Subject: CC2035 Plan Testimony

As you vote on the Central City 2035 draft, please protect: 1) the LAST fully protected view of Mt. Hood from the riverbank at Salmon Springs Fountain, 2) views of Mt. Hood's timberline from the Vista Bridge, and 3) views of the Vista Bridge.

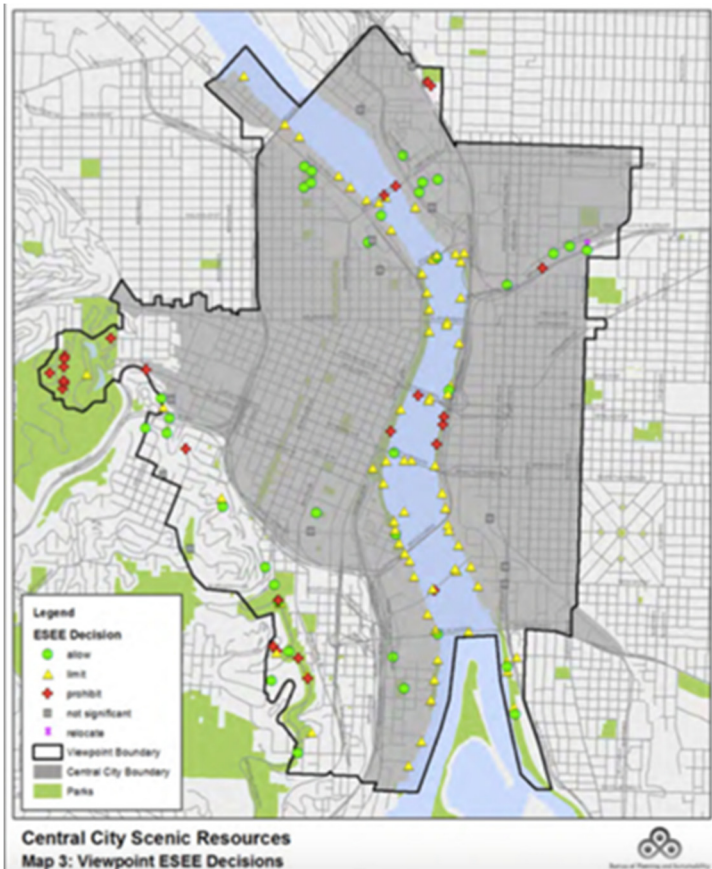
Many currently protected views of Mt. Hood from the banks of the Willamette River have been lost in this draft. In this page 62 map, Salmon Springs is the only red x on the banks of the river.

Salmon Springs Fountain will be the ONLY remaining fully protected view of Mt. Hood from the riverbank. This view is iconic to Portland’s sense of place--which is what draws tourists here. It would be a tragedy for Portland’s sense of place and robust tourist economy to lose this last fully protected view of Mt. Hood from the riverbank.

Figure 16: View of Central City and Mt Hood from SW15 – Proposed Bonus Heights

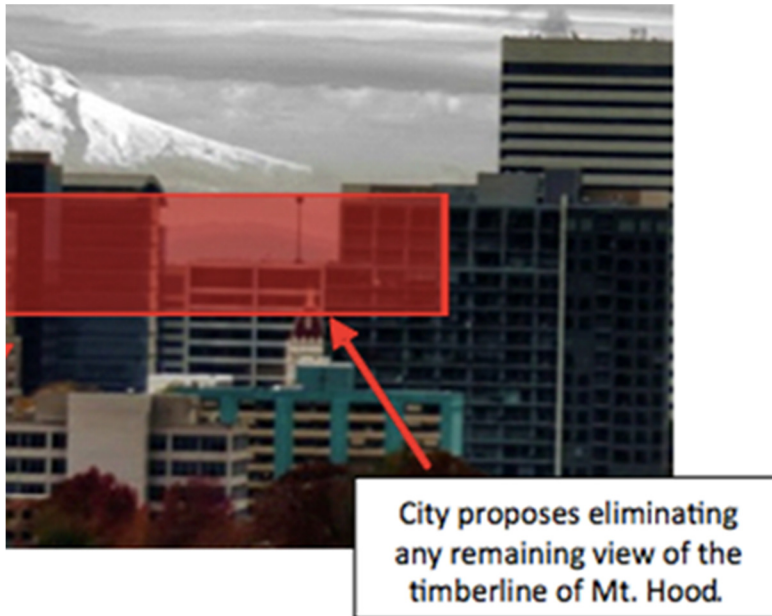
The current views to Mt. Hood from the Vista Bridge are being threatened by the heights proposed in this draft (above). Page 79 states: “The bottom elevation of the view corridor is set based on the height of existing buildings, rather than 1,000 ft below the timberline... With the recommended building heights the view of Mt Hood will remain as it is today...” This statement is untrue as can be seen in the pictures above and below. The view of Mt. Hood will change dramatically so that only the snowcap will be seen--where 1000’ below the timberline can be seen today. It is the contrast between timberline and snowcap that creates this dramatic view.

We ask for slightly lower heights in the center of the view corridor in order to preserve the existing views of 1000’ below the timberline. It will only take a slight modification to heights to protect this iconic view.

Please should honor the goals of the 1991 protection of this view. Heights should be reduced so that 1000' below the timberline can be seen, as it is today.
